ADDENDUM NUMBER 3
for
ADVANCED TREATMENT PROJECT
MEMORIAL PARKWAY TREATMENT PLANT
NORTHERN KENTUCKY WATER DISTRICT

FROM: CH2M HILL

TO: Plan Holders of Record

SECTION (PIPE PENETRATION AT EXTERIOR WALLS)

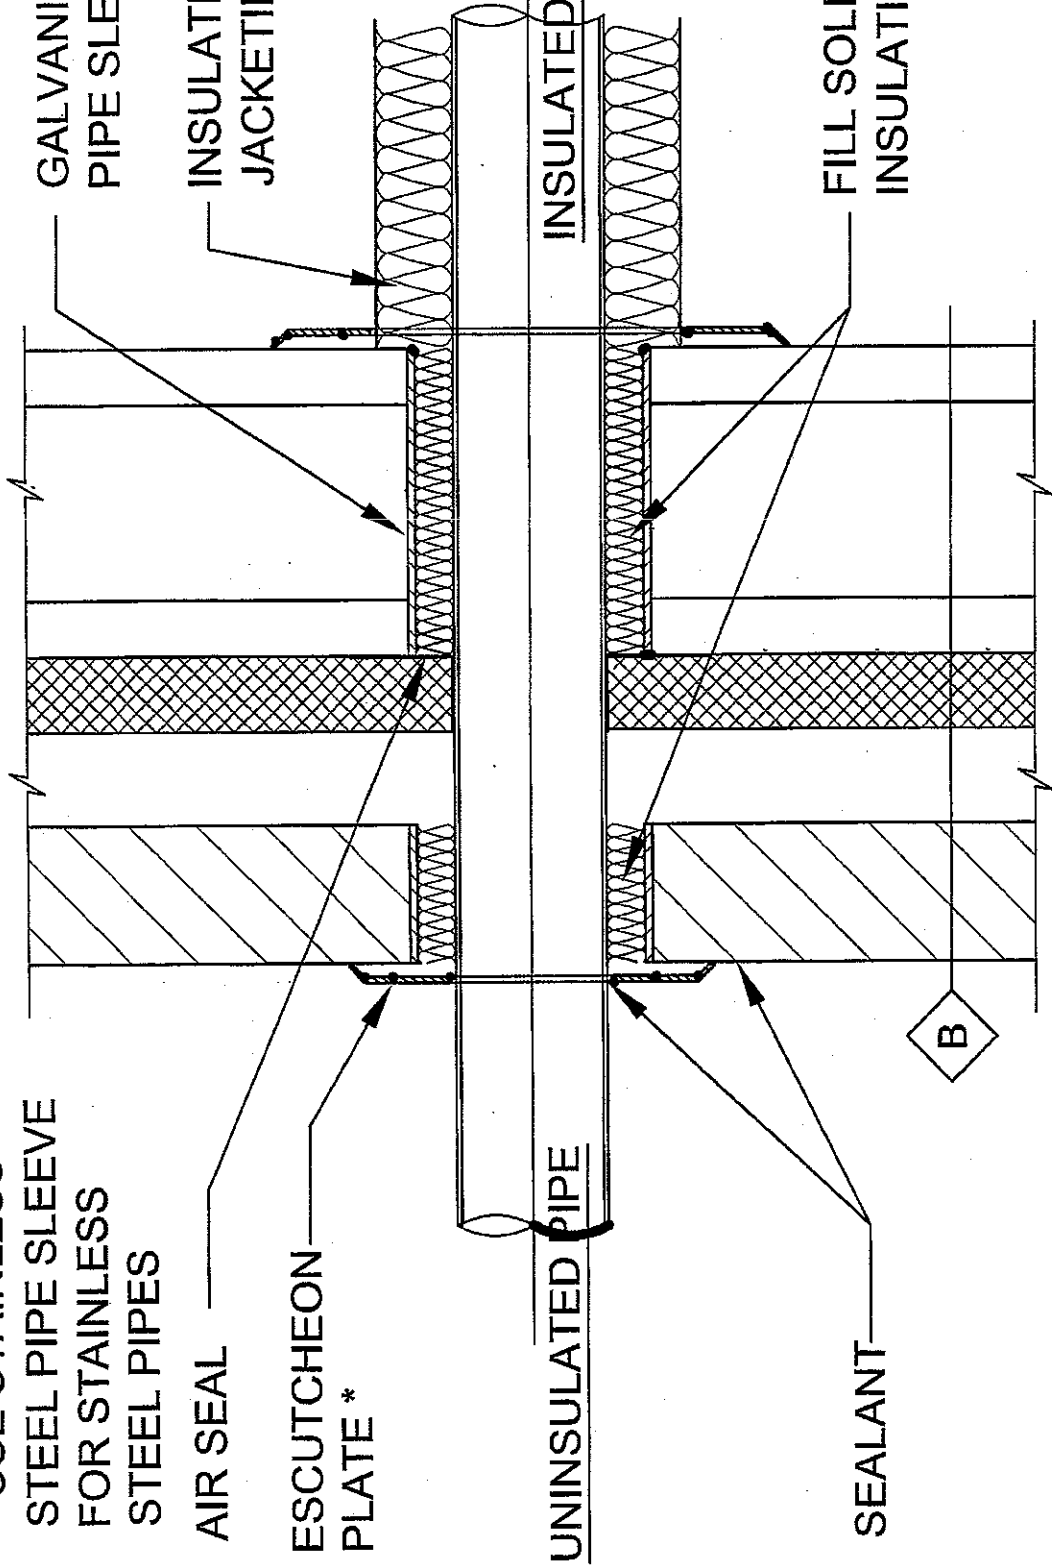
Add the following details to this sheet which are attached to this Addendum:

- SK A-1 Typical Pipe Penetration at Exterior walls
- SK A-2 Typical Pipe Penetration Through Floor assemblies
- SK A-3 Typical Pipe Penetration Through Fire separations
